ND-2012-0010
February 10, 2012

Subject: **PSEG Early Site Permit Application**
Docket No. 52-043
Response to Request for Additional Information, RAI No. 44, Surface
Faulting

RESPONSE to RAI No. 44

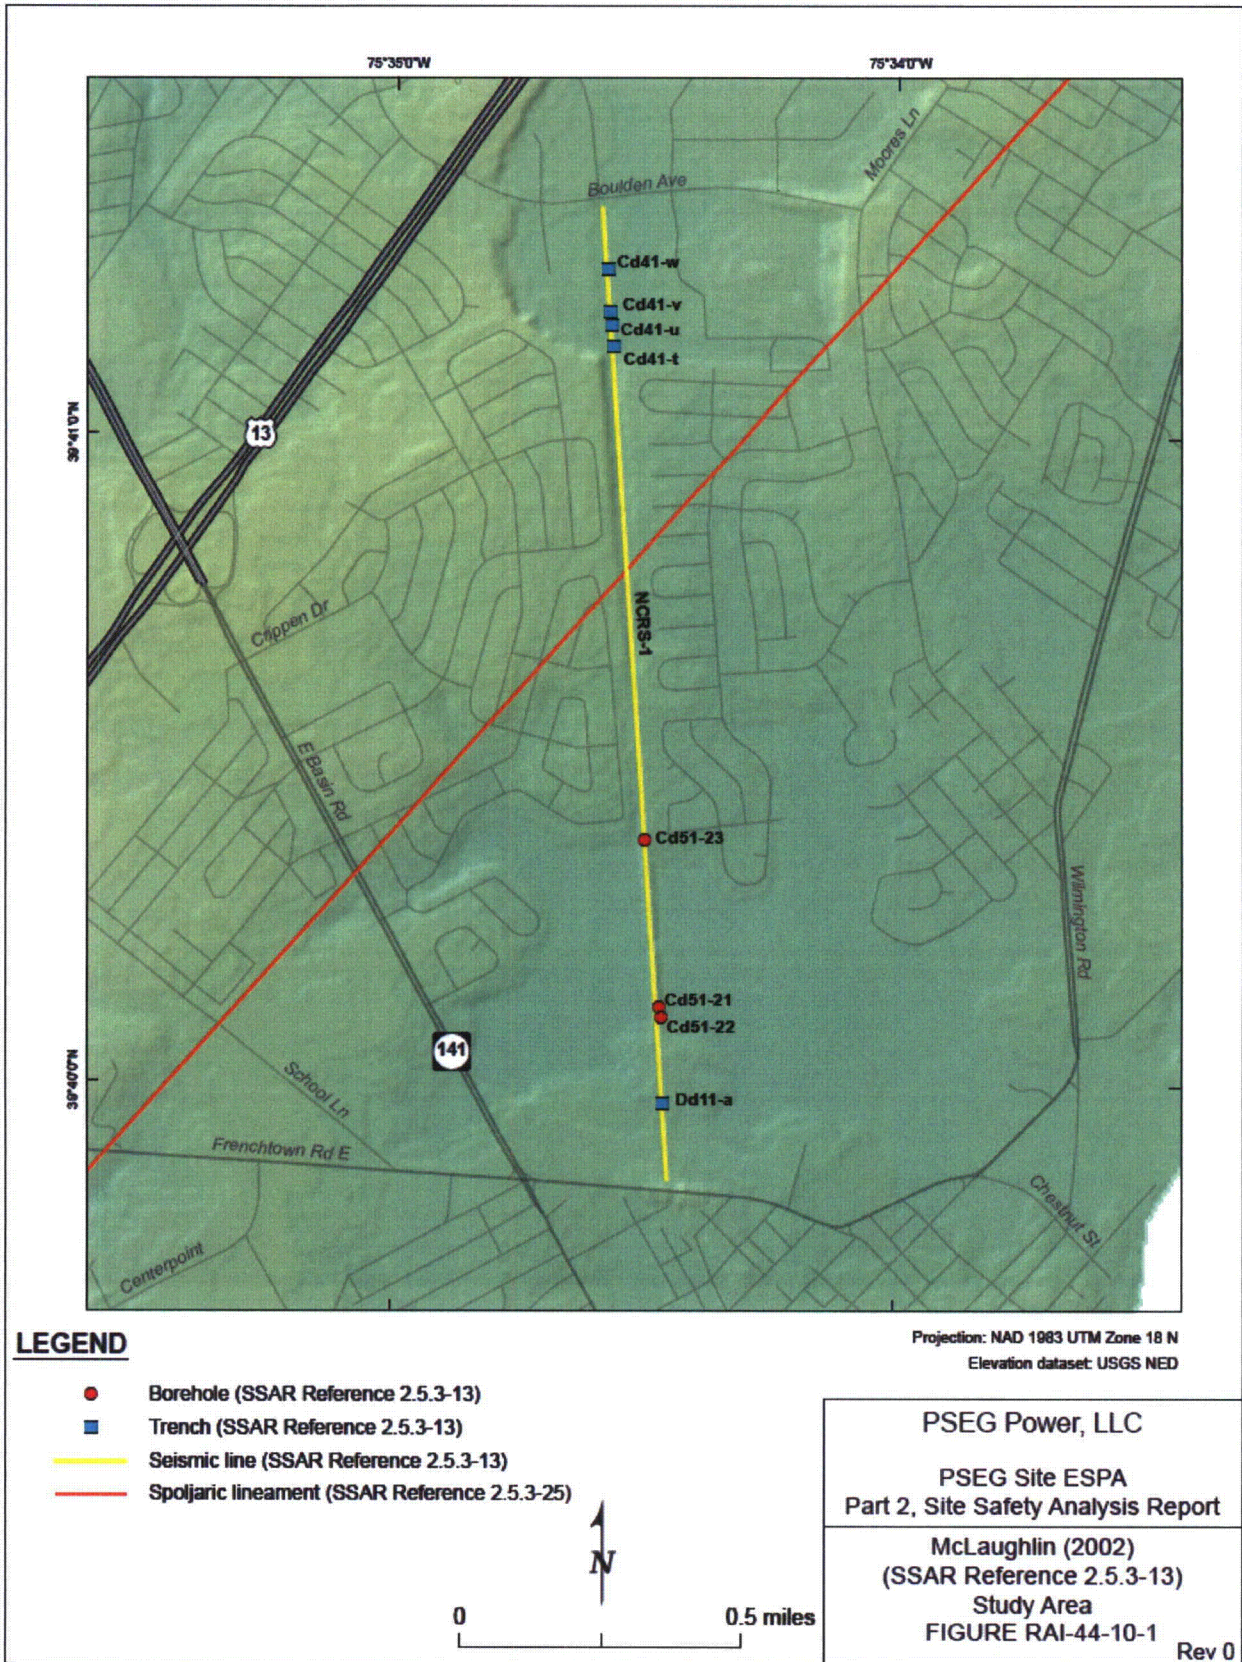
In Reference 2, the specific request for Question 02.05.03-10 was:

SSAR Subsection 2.5.3.2.2, "Faults Buried by Coastal Plain Sediments," discusses the lineaments and basement faults postulated by Spoljaric (1972, 1973, 1974, 1979), broadly known as the New Castle County faults, two of which extend into the site area as lineaments (based on Landsat data). The SSAR description distinguishes between the postulated basement faults and the lineaments, and states that the basement faults have been demonstrated to be pre-Cretaceous in age, thus posing no surface faulting hazard at the site. However, SSAR Subsection 2.5.3.2.2 does not summarize the data that demonstrate the validity of a pre-Cretaceous age. The SSAR further indicates that the interpretation of a young age for the lineaments is unsupported for the following reasons: (a) Borings have not revealed offsets in near-surface units that cross the projection of the lineaments; (b) earlier studies show that basement faults do not extend into Cretaceous or Tertiary units; (c) trenching of one lineament north of the PSEG site revealed unfaulted Tertiary and Quaternary units; and (d) Spoljaric (1974) noted that surface faulting was not evident along the lineaments. However, the SSAR does not indicate which lineament was trenched to conclude that Quaternary units were not offset along the lineament.

In order for the staff to adequately evaluate the potential for faulting within the PSEG site vicinity and at the PSEG site, and in compliance with 10 CFR 100.23 and in conformance to NUREG 0800, Section 2.5.3, "Surface Faulting," please clarify what data were used to demonstrate the validity of a pre-Cretaceous age for the basement faults of Spoljaric. Please also clarify which lineament was trenched and provide additional details of the trench investigation, as this action provides support for concluding that the lineaments do not represent Quaternary faults.

The Delaware Geological Survey conducted a detailed study in New Castle County to determine if there was any evidence for near-surface deformation related to lineaments or basement faults identified by Spoljaric (SSAR Reference 2.5.3-25) and to assess earthquake hazards in northern Delaware (SSAR Reference 2.5.3-13) (note this is also SSAR Reference 2.5.1-128, and is depicted on SSAR Figure 2.5.1-19). The study included a seismic reflection line (NCRS-1) designed to image the top 1500 feet of the subsurface, three deep borings (350-550 feet in depth to reach basement) that were designed to intersect postulated basement faults, and five shallow (5-8 feet in depth) trenches to examine surficial strata (Figure RAI-44-10-1). The data and conclusions presented in SSAR Reference 2.5.3-13 did not provide any evidence of shallow tectonic deformation or faulting along this transect.

The borings and the trenches were located within a mile of the proposed trace of a nearby northeast-trending Spoljaric lineament, and along strike of several basement

faults identified by Spoljaric to the southwest (SSAR Figure 2.5.1-19; Figure RAI-44-10-1; SSAR Reference 2.5.3-26).

The information from the five trenches, as described in SSAR Reference 2.5.3-13, is summarized below.

- Trench Cd41-t identified five lithologic units- mostly sands- interpreted as part of the Quaternary Columbia formation. The contacts between the units were horizontal.
- Trench Cd41-u described six lithologic units including upper portions of the Cretaceous Potomac Formation in addition to the Quaternary Columbia Formation. Contacts between the units dip gently (<10 degrees) to the north.
- Trench Cd41-v contained four lithologic units which dip northward, also composed of Potomac Formation overlain by Columbia Formation.
- Trench Cd41-w exposed clays tentatively assigned to the Columbia Formation that were cut by an erosional surface.
- Trench Dd11-a, located to the south of the other trenches, exposed flat-lying clays overlain by sands, interpreted as Potomac formation overlain by the Quaternary Lynch Heights Formation.

These trenches were located to test hypothesized faulting in early interpretations of the seismic reflection data. No evidence of faulting was encountered in any of the five trenches in the Potomac formation or the overlying Quaternary deposits (SSAR Reference 2.5.3-13). These trenches, along with the boring data, and reinterpretations of the seismic data indicate an unfaulted shallow section along the NCRS-1.

CD-ROM Containing Revised SSAR Figure 2.5.3-1

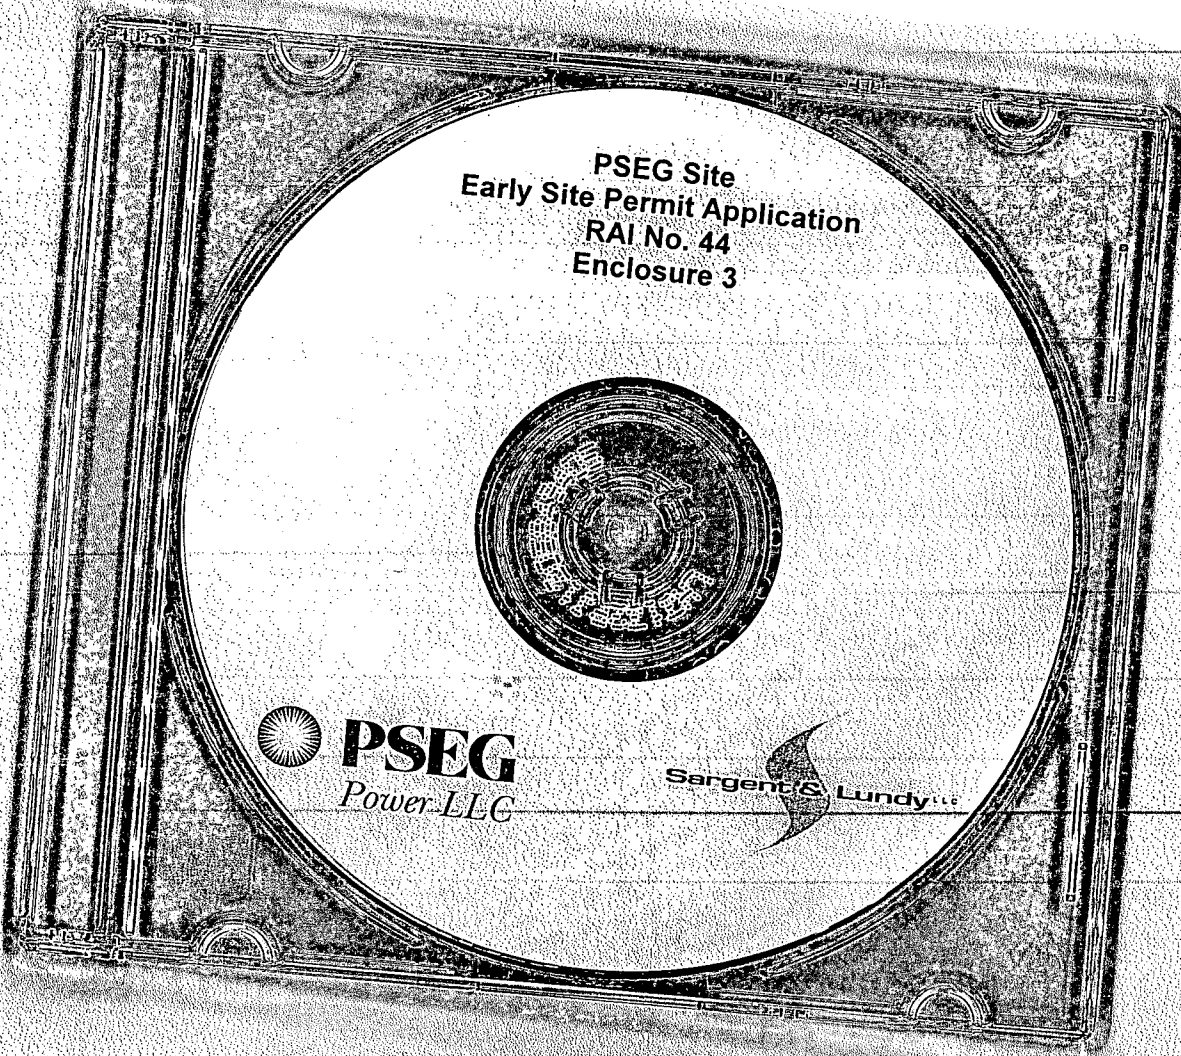
SSAR Figure 2.5.3-1 includes a north-northwest yellow line that is not defined in the figure legend and it is not clear what this line represents on the map showing site vicinity geology and seismology. The SSAR Figure 2.5.3-1 map legend identifies only Cretaceous and Quaternary coastal plain units, which is inconsistent with SSAR Figure 2.5.1-12a that shows tertiary units in the eastern portion of the site vicinity.

In order for the staff to adequately evaluate the potential for faulting within the PSEG site vicinity and at the PSEG site, and in compliance with 10 CFR 100.23 and in conformance to NUREG 0800, Section 2.5.3, "Surface Faulting," please update the legend in SSAR Figure 2.5.3-1 to be consistent with SSAR Figure 2.5.1-12a and please identify the north-northwest yellow line included in the map. Also, please explain the significance of Quaternary units in contact with Cretaceous units along the fall line west of the site.

The legend of SSAR Figure 2.5.3-1 should read Cretaceous-Quaternary units. The missing hyphen will be inserted on the revised figure as shown in Enclosure 3. The north-northwest trending yellow line is one of the lineaments identified by Spoljaric (SSAR Reference 2.5.3-25). The line color and style of the line depicting this lineament is also corrected in the updated version of SSAR Figure 2.5.3-1.

SSAR Figure 2.5.3-1 will be updated as specified in Enclosure 3 of this document.
